Rezoning Transportation Analysis

Petition Number: 2021-092

From: Lakisha Hull, AICP, LEED AP BD+C

Reviewer: Kevin Parker

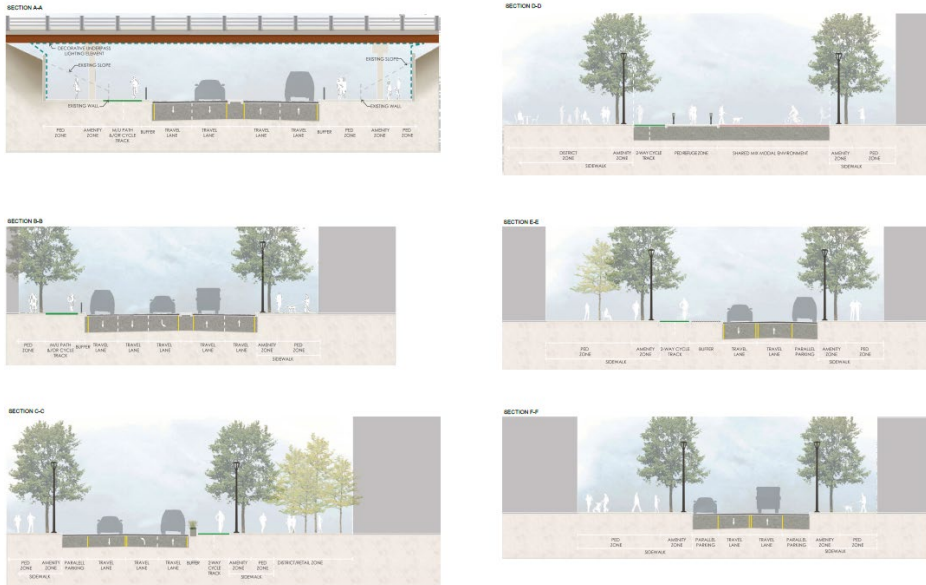
Update to Comment as a Result of the 08-16-2021 Site Plan:

The proposed and existing Morehead Street right of way dedication must be labeled dimensioned from the existing centerline. **Outstanding comment (10/21/2021 Site Plan) - Revise the site plan conditional notes and legends that all new streets shall be determined as public or private during**

permitting. Revise cycle track along McDowell Street to include a sidewalk utility easement, where appropriate.

Sheet RZ-1.1 – Typical Sections

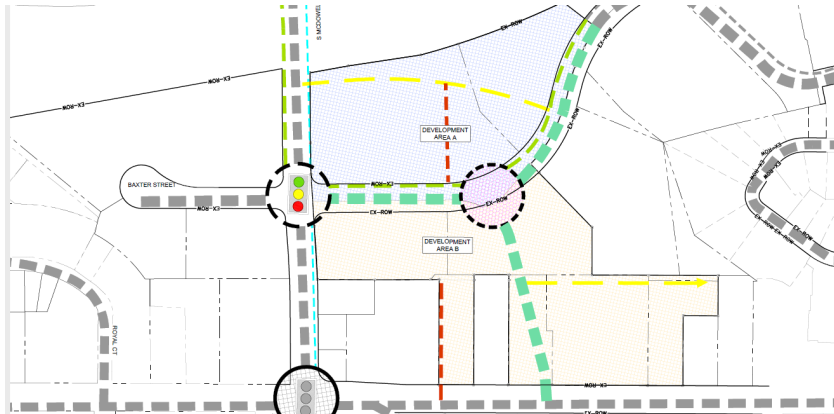
- ~~**Right of way and Other Infrastructure Dimensions:** Revise Rezoning Sheet RZ 1.1 to include detailed dimensions for each infrastructure item, and the total right-of-way for the cross sections shown. Refer to the USDG Cross sections and on street parking details, located within the Charlotte Land Development Standards Manual, to determine the appropriate widths associated with each infrastructure item and the cross sections' total widths. Revise the site plan sheets by clearly labeling each public and private street section as well as each access point. Labeling each street section and access point will allow for thorough comments throughout the rezoning and permitting process. CDOT prefers the separated cycle track and sidewalk for McDowell Street (cross sections A-A and B-B). Please note: The following right of way dimensions proposed are conceptual and may be altered as coordination with CDOT throughout the rezoning process ensues.~~

- ~~**Morehead Street: (10/21/2021 Site Plan) - 56-feet of right-of-way dedication measured from the existing road centerline.**~~
 - ~~**McDowell Street:** 110 feet of total right-of-way dedication, 55 feet measured from the existing road centerline to each right of way line.~~

- ~~**Baxter Street (Section C-C)** – 93 feet of total right of way dedication, 46.5 feet measured from the existing road centerline to each right of way line.~~

- ~~**Baxter Street (Section D-D)** – 86 feet of total right-of-way dedication, 43 feet measured from the existing road centerline to each right of way line.~~

- ~~**Baxter Street Extension (Section E-E)** – 93 feet of total right of way dedication, 46.5 feet measured from the existing road centerline to each right of way line.~~

- ~~**Proposed Public Street (Section F-F)** – 73 feet of total right of way dedication, 36.5 feet measured from the existing road centerline to each right of way line.~~

Sheet RZ-1.3 – Ped and Bike Connectivity

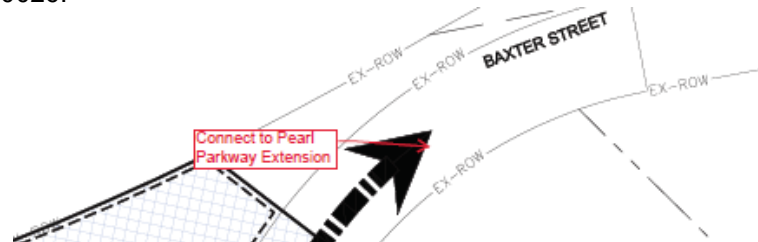
4. ~~Revise the Rezoning Sheet RZ-1.0 and RZ-1.1 by establishing a cross section associated with the proposed private street connecting McDowell Street to Baxter Street Extension. Include the cross section on Rezoning Sheet RZ-1.1.~~
